MODEL RAH SERIES TROUBLE SHOOTING NOTES**DIFFICULTY ENCOUNTERED****CAUSE AND REMEDY**

→ RAK RADIO RECEIVING EQUIPMENT FIELD CHANGE NO. 1 and RAL RADIO RECEIVING EQUIPMENT FIELD CHANGE NO. 1 PROVIDING CONCENTRIC ANTENNA JACK

MODIFICATION TO BROADEN THE TUNING OF MODEL RAS RECEIVING EQUIPMENTS

MODIFICATION TO IMPROVE THE TUNING CONDENSERS OF MODEL RAS RECEIVING EQUIPMENTS

FIGURE 1.—Contents of kit.

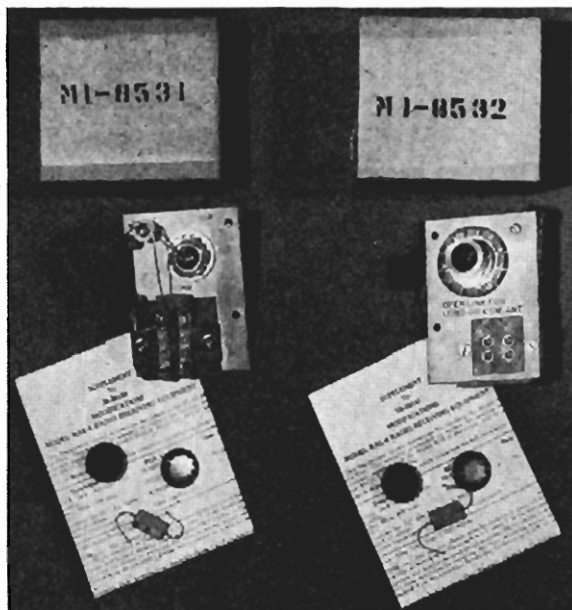
Each modification kit contains two complete assemblies as shown in Figure 1; one (MI-8531) is for the model RAK-6, and one (MI-8532) for the model RAL-6. The two assemblies are identical except for the coupling capacitor, symbol C-101. This capacitor has a rating of 300 mmfd. on the RAK-6 assembly and 440 mmfd. on the RAL-6 assembly. One spare coupling capacitor is furnished for each assembly and should be placed in the respective receiver spare parts boxes. The two plug buttons supplied with each assembly are to be inserted in the two binding-post holes in the cabinet which are not required after installation of the new assembly.

The modification consists, basically, of removing the present binding-post-type antenna terminal board assembly and replacing it with the new concentric jack type assembly. Complete instructions and diagrams are packed with each kit and should be carefully followed. These instruction sheets should be inserted in the respective instruction books after completion of the modifications.

FIGURE 2.—Revised first and second i-f stages.

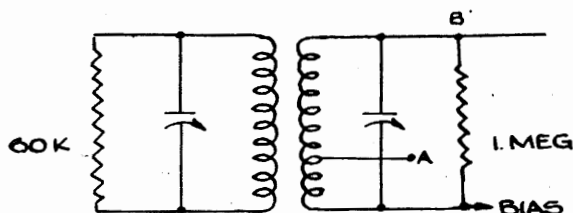
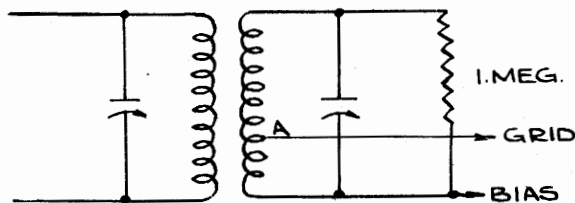
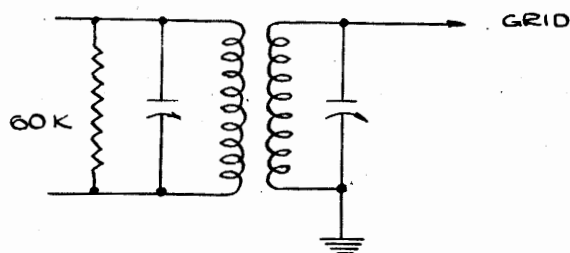
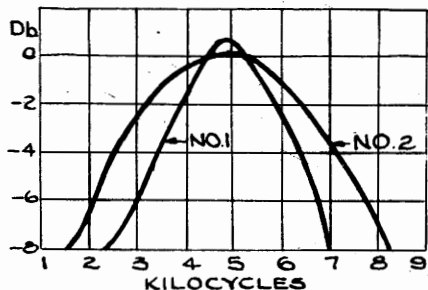
The following method of broadening the i-f response by overcoupling is known as Navy Yard Pearl Harbor plan No. RV-46-A-124. The modification just described is preferred to this modification. In addition, it is pointed out that this is a delicate modification and should not be attempted except in a laboratory. It was accomplished as follows:

(2) The secondaries of the first and second stage intermediate-frequency transformers have a tap to which the grid was connected in the original installation as shown at "A" in Figure 1. The grid connection was removed from this tap and attached to the extreme end of the coil which

is connected to the stator plates of the trimmer condenser as shown at "B" in Figure 2.

(3) A 1/2-watt resistor of 60,000 ohms was connected in parallel with the primary circuit of each i-f stage, as shown in Figures 2 and 3.

(4) Selectivity before and after modification is shown in Figure 4.

FIGURE 1.—Main tuning condenser assembly.

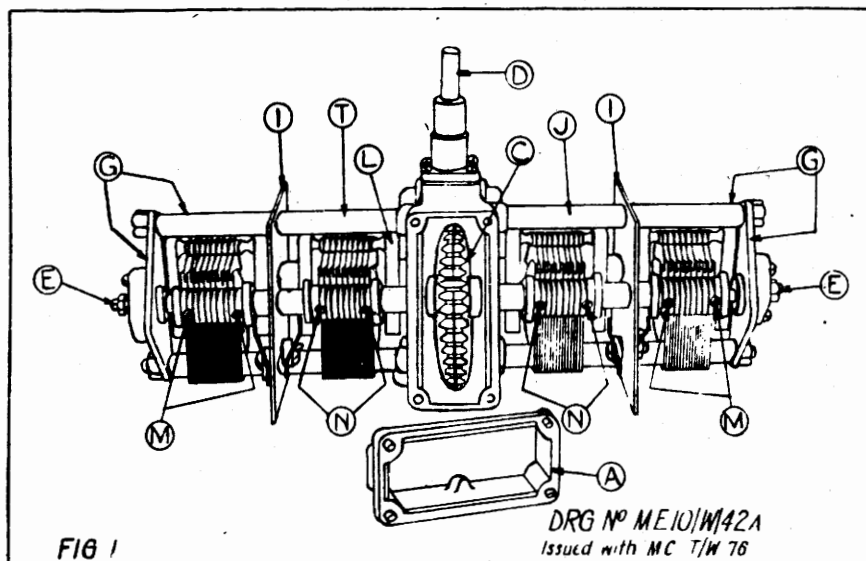
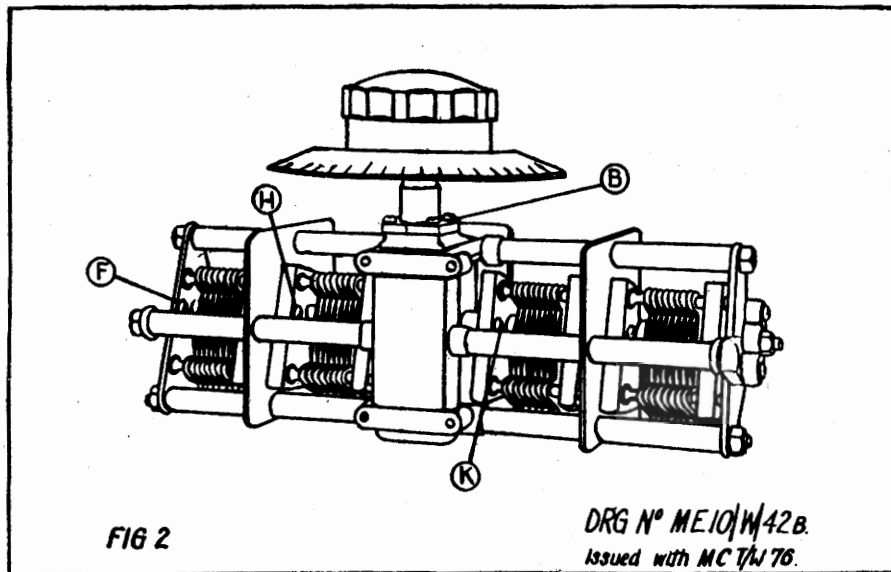
In certain RAS equipments the drive on the main tuning condenser has seized when working under conditions of high humidity. In order to effect a positive cure for this defect it is necessary to completely strip the assembly, remove a small amount from the bearing surface of the main shaft and finally to impregnate the bakelite covering of the shaft with wax to prevent further ingress of moisture. This modification should be carried out as required, or when an equipment is returned for complete overhaul. The necessary steps are as follows:

(6) Remove four screws retaining gear case top cover Figure 1 (A) and four screws retaining gear case cover Figure 2 (B).

(7) Bind a single loop of #12 B & S copper wire across teeth of large gear wheel Figure 1 (C) to retain the two halves in position; remove drive spindle Figure 1 (D) complete with thrust spring and two washers.

(8) Slacken off bearing screws Figure 1 (E) and remove three nuts from each plate.

(10) Remove end plates and spacing pieces, Figure 1 (G).

(11) Loosen Allen set screws securing outer rotors Figure 1 (M) to spindle and remove rotors taking care not to distort vanes.

(13) Remove screens complete with outer stators attached Figure 1 (I) and spacing pieces Figure 1 (J).

(15) Remove inner stators Figure 1 (L).

(16) Loosen Allen set screws securing inner rotors Figure 1 (N) to spindle and remove rotors, taking care not to distort vanes.

FIGURE 1.—Installation of 50063 preselector.

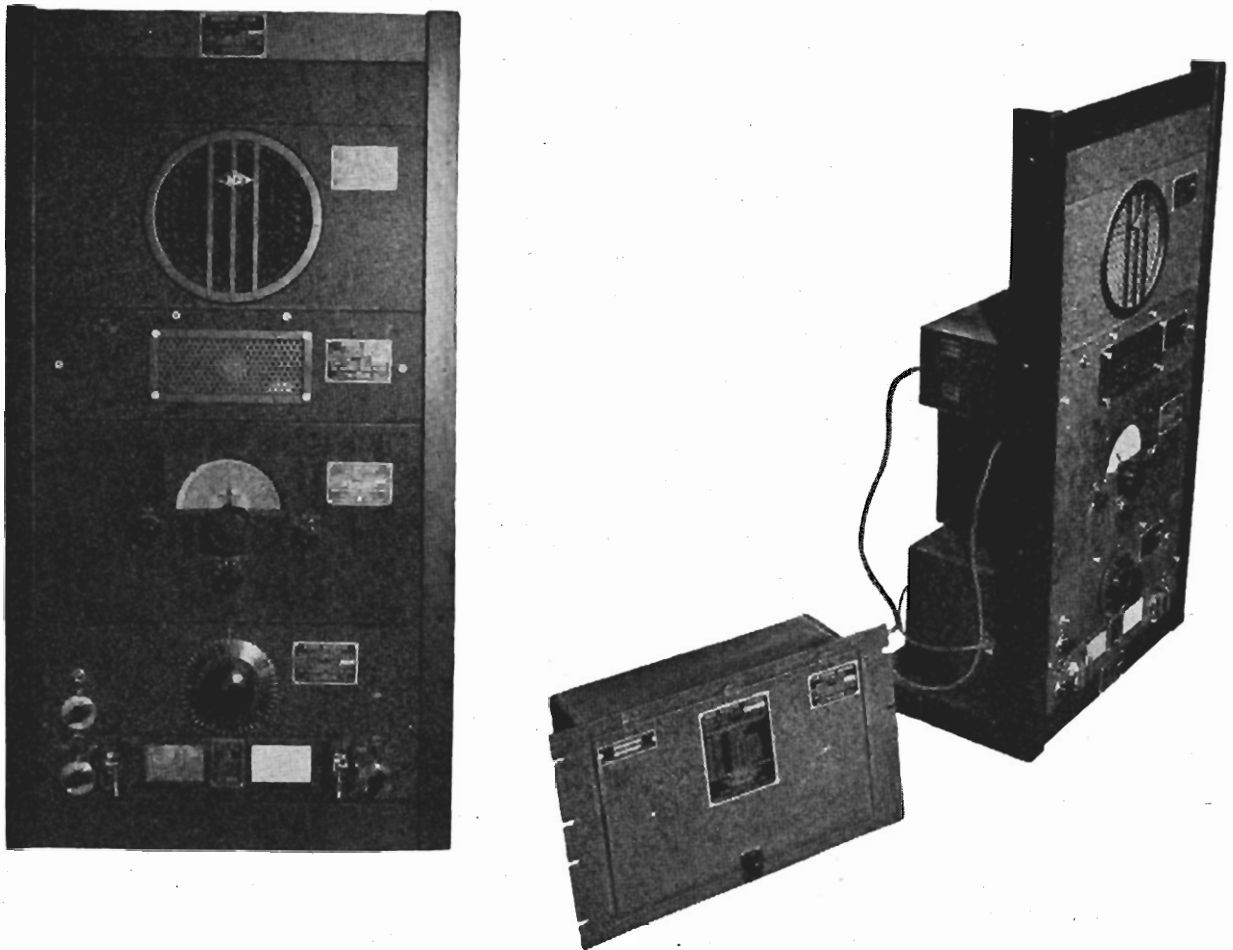
The Norfolk Navy Yard has developed a unique method of mounting the type CME 50063 preselector for use with the model RAS series receiver. This method of mounting offers the advantages of short leads between equipments, pleasing appearance, compact installation, ease of operation, control of both equipments on a single a-c switch, etc.

A standard relay rack panel is drilled to accommodate the dial and knobs of the preselector and the unit is installed behind the panel as

shown in Figure 1. The coil container is removed from the rack and installed elsewhere in a convenient location.

FIGURE 1.—Installation of plug adapter.

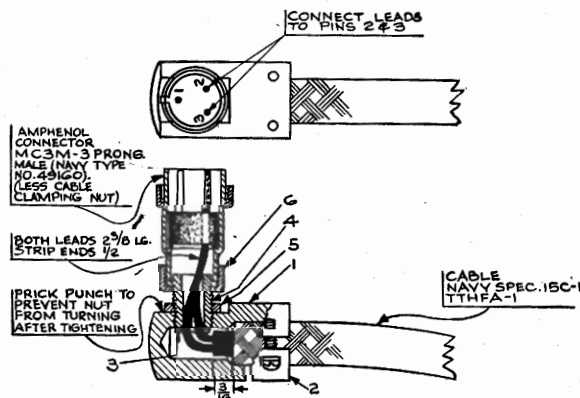
Purpose.—To adapt the audio output plug to fit the type TTHFA-1 cable specified for use in audio circuits.

Procedure.—The plug adaptor is to be installed in the following manner: (The numbers, in brackets, referenced throughout the text, refer to Fig. 1.)

(2) Strip $\frac{1}{2}$ " off the ends of the two conductors as shown in Figure 1.

(6) Assemble bushing [4], locknut [5], coupling nut [6] and plug, Navy type CPH-49160. Insert the conductor leads into pins no. 2 and no. 3, as shown in Figure 1.

(7) Before tightening the locknut [5] note positions of the key and connections. Be sure that the positions agree with Figure 1. Tighten the locknut [5].

FIGURE 1.—Installation of plug adapter.

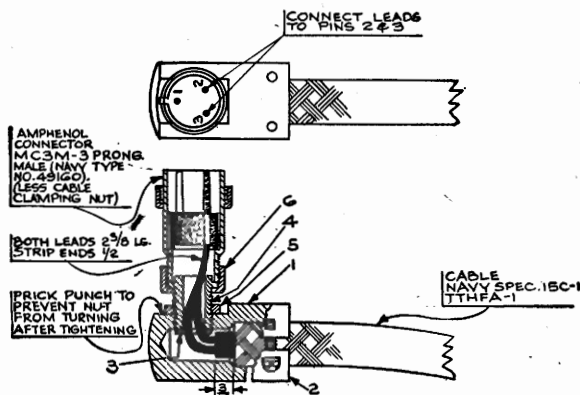
Purpose.—To adapt the audio output plug to fit the type TTHFA-1 cable specified for use in audio circuits.

Procedure.—The plug adapter is to be installed in the following manner: (The numbers, in brackets, referenced throughout the text, refer to Fig. 1).

(2) Strip $\frac{1}{2}$ " off the ends of the two conductors as shown in Figure 1.

(6) Assemble bushing [4], locknut [5], coupling nut [6] and plug, Navy type CPH-49160. Insert the conductor leads into pins no. 2 and no. 3, as shown in Figure 1.

(7) Before tightening the locknut [5] note positions of the key and connections. Be sure that the positions agree with Figure 1. Tighten the locknut [5].

FIGURE 1.—RBB/RBC receivers band switch stators—before and after modification.

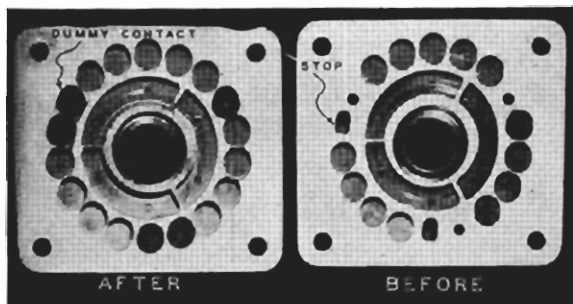
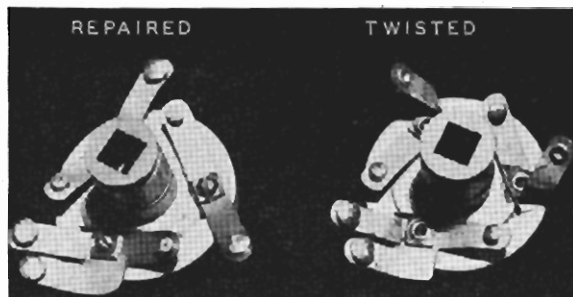
Purpose.—To prevent the band switch rotor contacts from twisting.

Procedure.—Equipments should be modified as shown in the accompanying photographs, Figures 1 and 2. The modification, which was

suggested by C. E. Swiger, RT 1/c of the U. S. S. *Cascade* (AD-16), consists of removing the stop pins and filling the holes on the band switch with plugs made of bakelite or other suitable insulating material. The plugs should be made as shown, having approximately the same top dimensions as the switch contact points. It is believed that the photographs are self-explanatory.

FIGURE 1.—Installation of plug adapter.

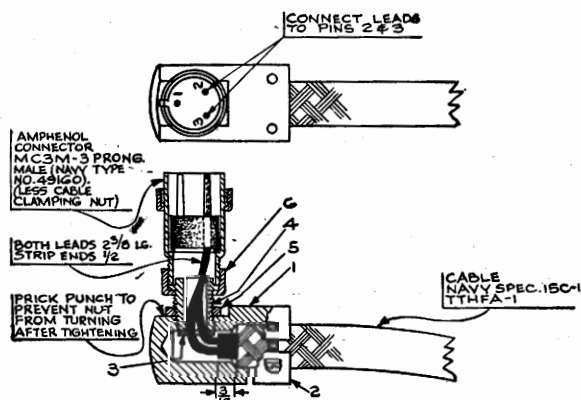
Purpose.—To adapt the audio output plug to fit the type TTHFA-1 cable specified for use in audio circuits.

Procedure.—The plug adaptor is to be installed in the following manner: (The numbers, in brackets, referenced throughout the text, refer to Fig. 1).

(2) Strip $\frac{1}{2}$ " off the ends of the two conductors as shown in Figure 1.

(6) Assemble bushing [4], locknut [5], coupling nut [6] and plug, Navy type CPH-49160. Insert the conductor leads into pins no. 2 and no. 3 as shown in Figure 1.

(7) Before tightening the locknut [5] note positions of the key and connections. Be sure that the positions agree with Figure 1. Tighten the locknut [5].

FIGURE 1.—RBB/RBC receivers band switch stators—before and after modification.

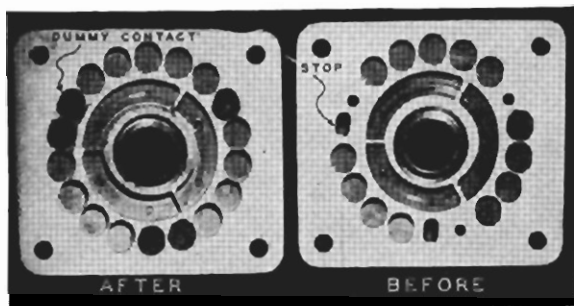
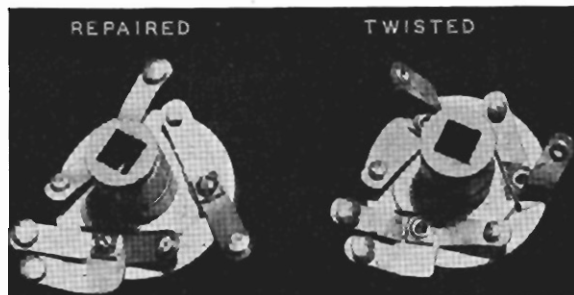
Purpose.—To prevent the band switch rotor contacts from twisting.

Procedure.—Equipments should be modified as shown in the accompanying photographs, Figures 1 and 2. The modification, which was

suggested by C. E. Swiger, RT 1/c of the U. S. S. *Cascade* (AD-16), consists of removing the stop pins and filling the holes on the band switch with plugs made of bakelite or

other suitable insulating material. The plugs should be made as shown, having approximately the same top dimensions as the switch contact points. It is believed that the photographs are self-explanatory.

FIGURE 1.—Modification of model RBH-1 to provide carrier-controlled noise suppression action.

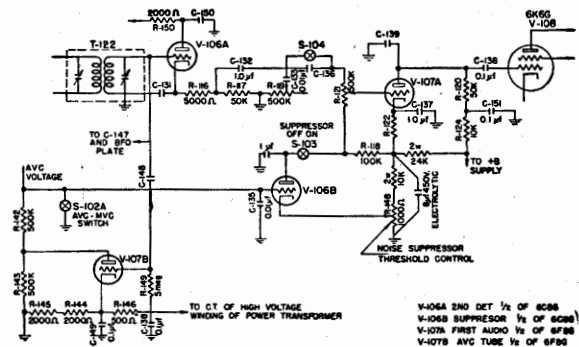
The following modification to provide carrier-controlled noise suppression action in the model RBH-1 radio receiver was proposed by Henry L. Fletcher, CRT (AA) (T) USNR of the U. S. S. *Eichenberger* (DE-202). This modification blocks the audio system so that no sound is heard in the loudspeaker until a carrier wave comes on. The a-v-c voltage developed by the carrier in the a-v-c tube then unlocks the audio enabling reception of the message.

In the original modification resistor R-148 and switch S-103 which were employed in the "S-meter" circuit have been used, thereby removing the S-meter from the circuit. If it is desired to retain the S-meter feature, an additional potentiometer of 1,000 ohms and an S. P. S. T. switch must be procured and mounted on the front panel on the receiver. Other parts required are:

The wiring in the receiver is rearranged in accordance with Figure 1, utilizing compon-

ents already in the receiver as required. Resistor R-148 functions as a noise suppression threshold control or an adjustment which determines the strength of the incoming carrier necessary to unlock the audio system. Switch S-103 is used to remove the noise suppression feature if desired. The circuit is adjusted by setting the suppressor threshold control so that atmospheric disturbances are

FIGURE 1.—Graph of the indications on the input meter while setting up the RCK tuning system.

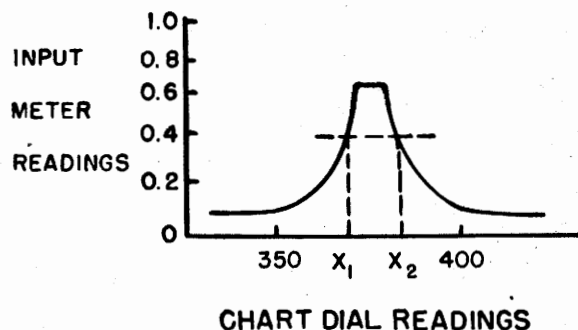
Figure 1 indicates in graph form the indications obtained on the input meter. For instance, if dial readings X1 and X2 are 365 and 385, respectively, the detent should be set at $\frac{385 + 365}{2}$

FIGURE 1.—Installation of plug adapter.

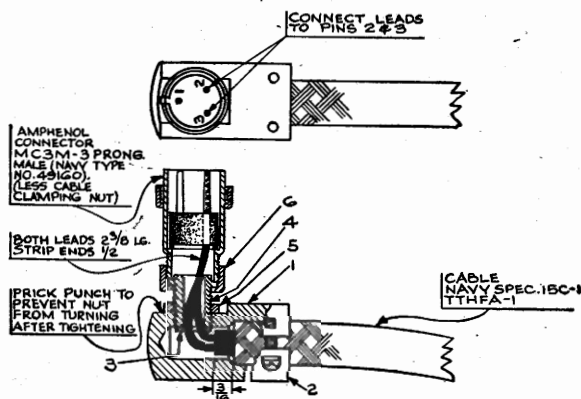
Purpose.—To adapt the audio output plug to fit the type TTHFA-1 cable specified for use in audio circuits.

Procedure.—The plug adapter is to be installed in the following manner: (The numbers, in brackets, referenced throughout the text, refer to Fig. 1.)

(2) Strip the ends of the two conductors $\frac{1}{2}$ " as shown in Figure 1.

(6) Assemble bushing [4], locknut [5], coupling nut [6] and plug, Navy type CPH-49160. Insert the conductor leads into pins no. 2 and no. 3, as shown in Figure 1.

(7) Before tightening the locknut [5] note positions of the key and connections. Be sure that the positions agree with Figure 1. Tighten the locknut [5].

FIGURE 1.—Field change No. 1 to the model RDP panoramic adaptor.

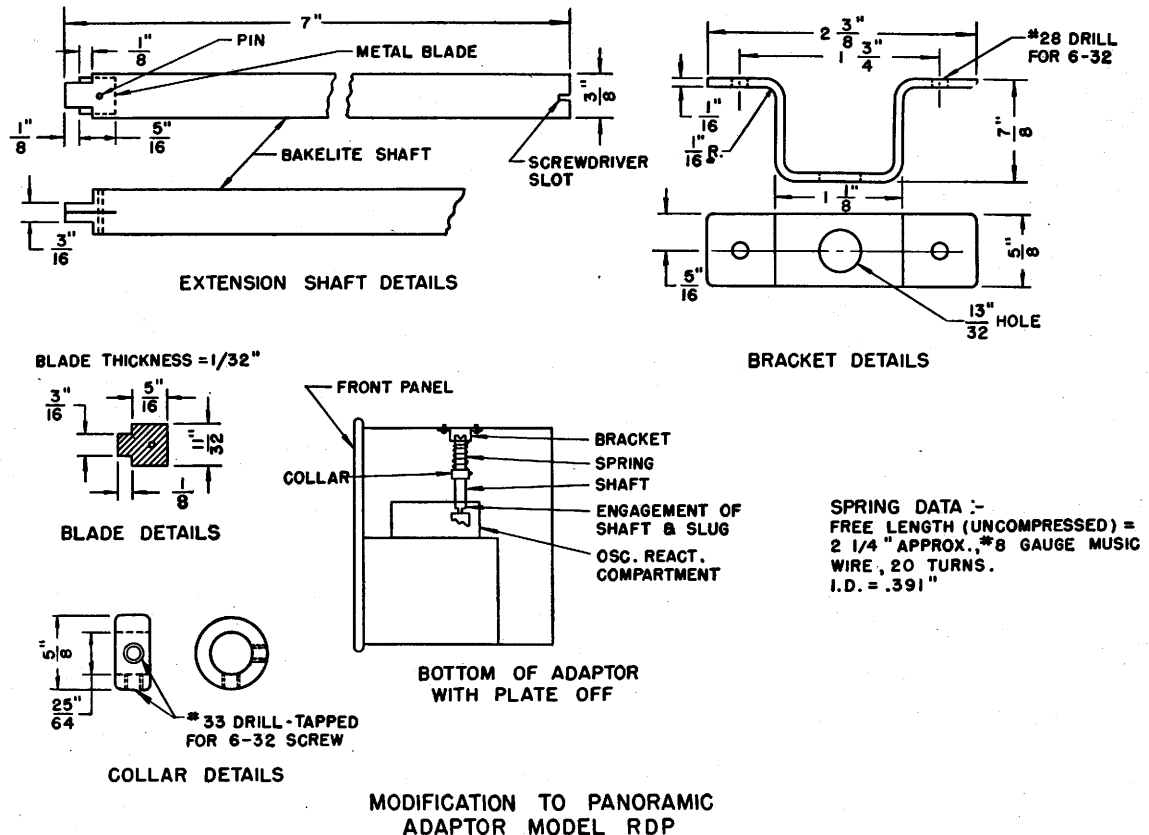
Purpose.—To alleviate alignment difficulties and safeguard personnel.

Procedure.—Details of this modification are shown in Figure 1. Minor alterations may be made to meet the particular needs of the activity making the modification.

FIGURE 1.—Modification of power pack of model RU receiving equipment.

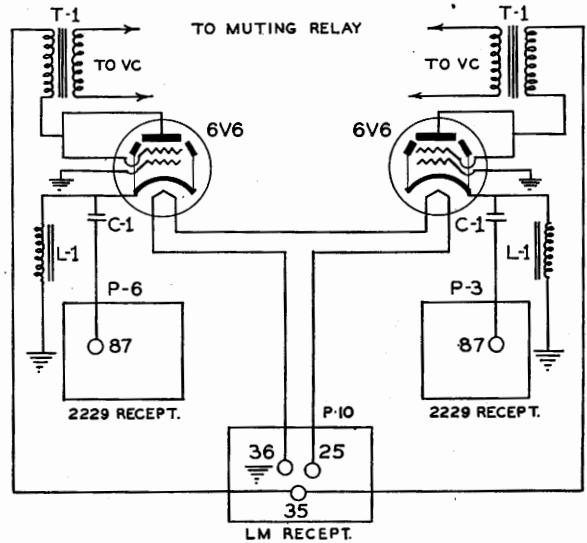
RU receivers and a-c power packs have been received and installed in various Naval Air Activity Control Towers. At the Naval Air Training Bases, Corpus Christi, Tex., it was found necessary to modify the a-c power pack in order to bring each receiver output up to loud speaker volume. The modification was made as illustrated in Figure 1.

— CHANGE R-10 IN GF-RU-LM POWER SUPPLY TO
 A 5000Ω 10 WATT RESISTOR
